STATE OF DELAWARE  
EXECUTIVE DEPARTMENT  
OFFICE OF MANAGEMENT AND BUDGET  
STATE PLANNING COORDINATION

RE: PLUS review – PLUS 2005-11-03; Old Courseys Mill

Thank you for meeting with State agency planners on November 30, 2005 to discuss the proposed plans for the Old Courseys Mill project to be located southeast intersection of Roesville Road and Canterbury Road, southwest of Frederica.

According to the information received, you are seeking site plan approval for 213 residential units on 83.60 acres.

**Map of Old Coursey's Mill PLUS 2005-11-03, with excellent recharge in green with affected parcels outlined in light blue.**

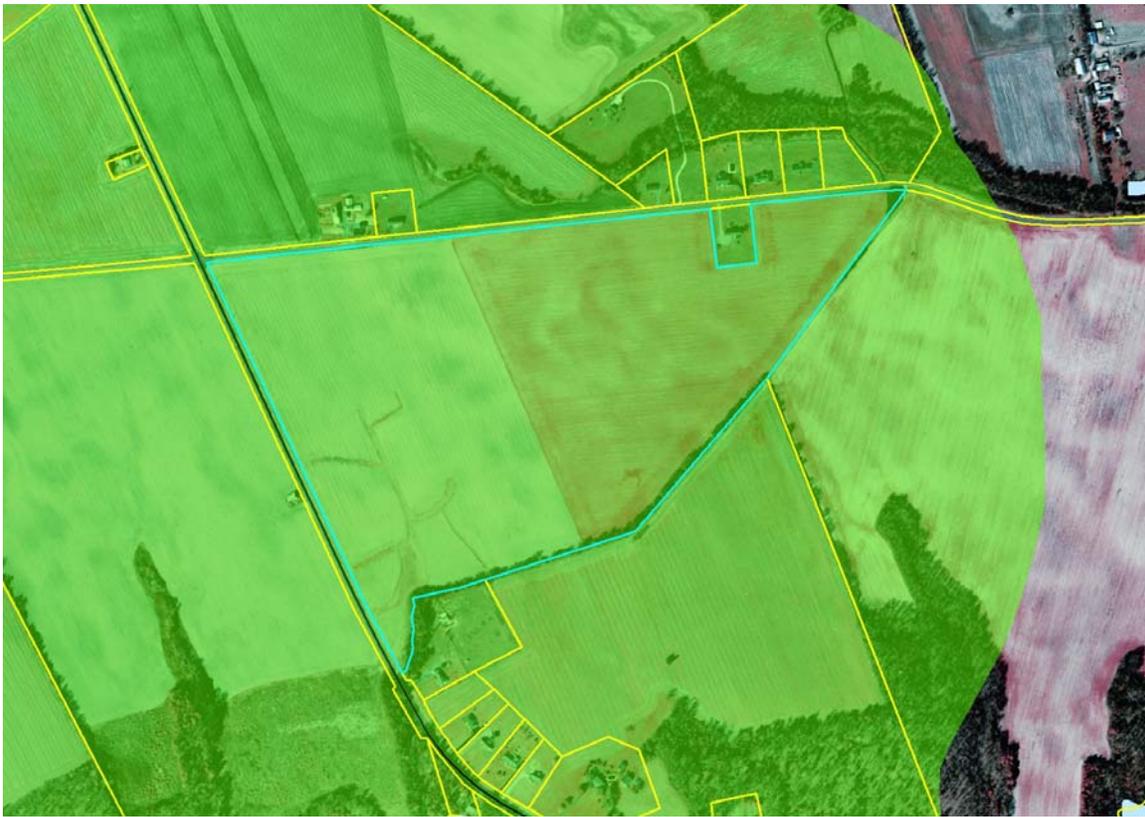
The DNREC Water Supply Section has determined that it falls entirely within an excellent recharge area (see following map and attached map). Excellent recharge areas near-surface areas within which precipitation infiltrates the land surface to the unconfined aquifer at a more rapid rate than other areas.

The DNREC Water Supply Section recommends that the portion of the new development within the excellent recharge area not exceed 50% impervious cover. Further, some allowance for augmenting ground-water recharge should be considered if the impervious cover exceeds 20% but is less than 50% of that portion of the parcel within this area. The purpose of an impervious cover threshold is to minimize loss of recharge (and associated increases in storm water) and protect the quality and quantity of ground water and surface water supplies. The impervious cover is proposed to change from 0% to 13%. This is below the threshold value for recommendations. The developer has effectively utilized available land to preserve the open space in the proposed development.
